Appendix B

MINUTES OF STEERING COMMITTEE MEETINGS

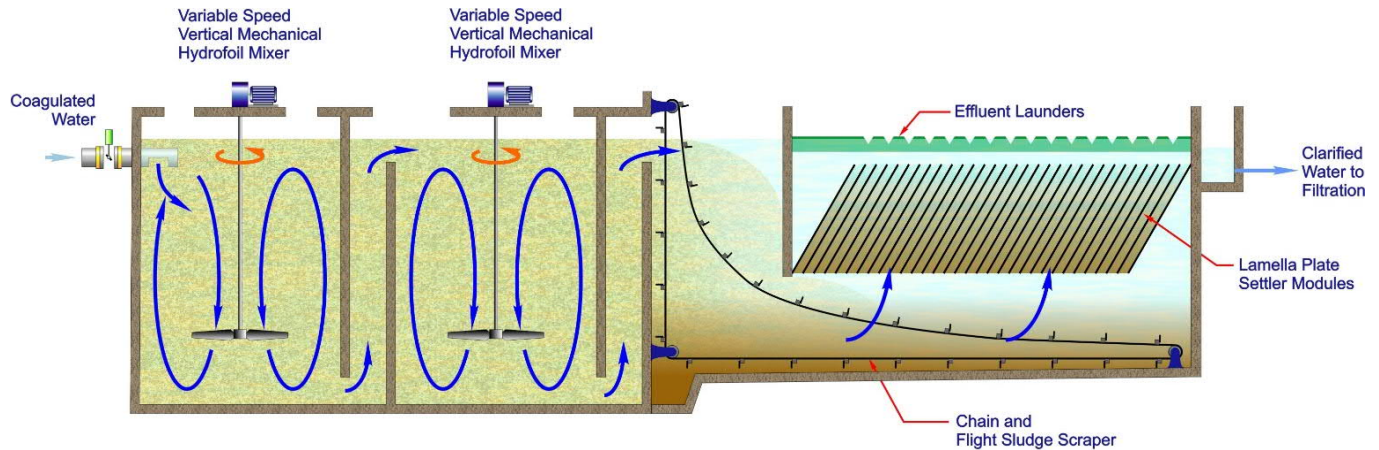
Figure 5 Schematic Diagram of High Rate Clarification (with Coagulation and Flocculation)

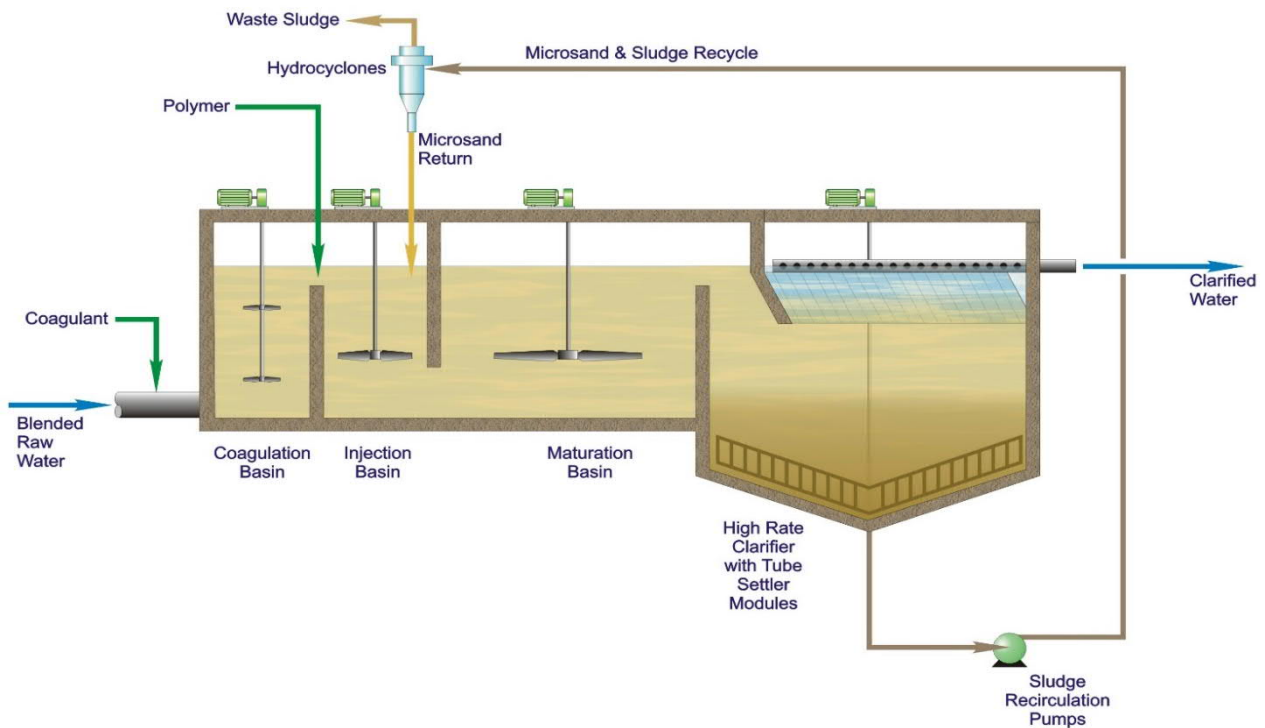
Figure 6 Schematic Diagram of Ballasted Flocculation/Clarification Process (Actiflo®)

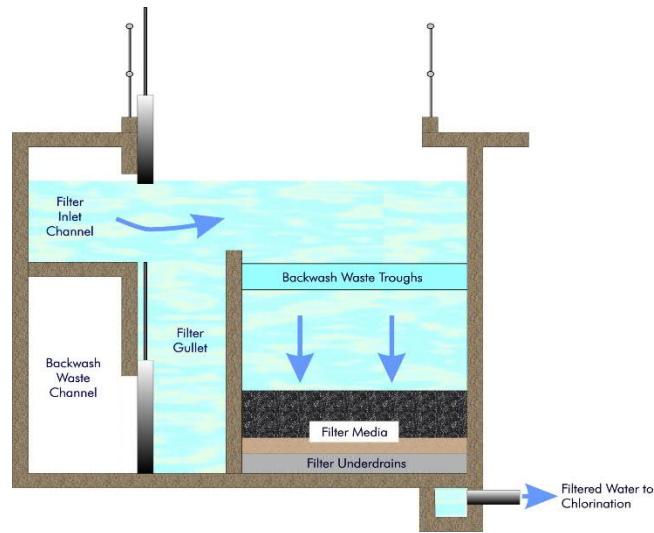
Direct filtration process consists of chemical coagulation, flocculation, and granular media filtration for the effective removal of particulate and turbidity from the water. Direct filtration eliminates the use of the clarification process from the train; therefore, allowing the filter material itself to do the work of straining contaminants from the water (Figure 8). The treatment processes used in direct filtration are fundamentally the same as those previously described, with the only exception that the clarification step is removed. Filter design is also usually different, typically with deeper, coarser beds being used to increase the solids holding capacity of the bed.

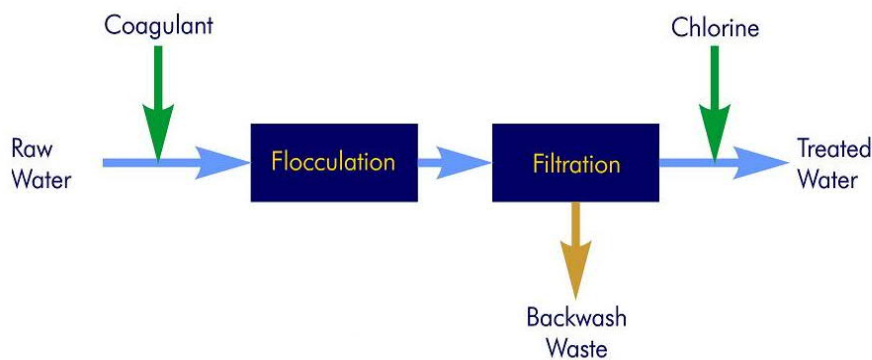
Low Pressure membrane filtration (henceforth termed simply membrane filtration) is a pressure or vacuum-driven physical separation process in which particulate matter is rejected by an engineered permeable membrane. The plastic filter membranes have a very small pore size capable of straining out particles without the need of chemical coagulation, flocculation or clarification processes.
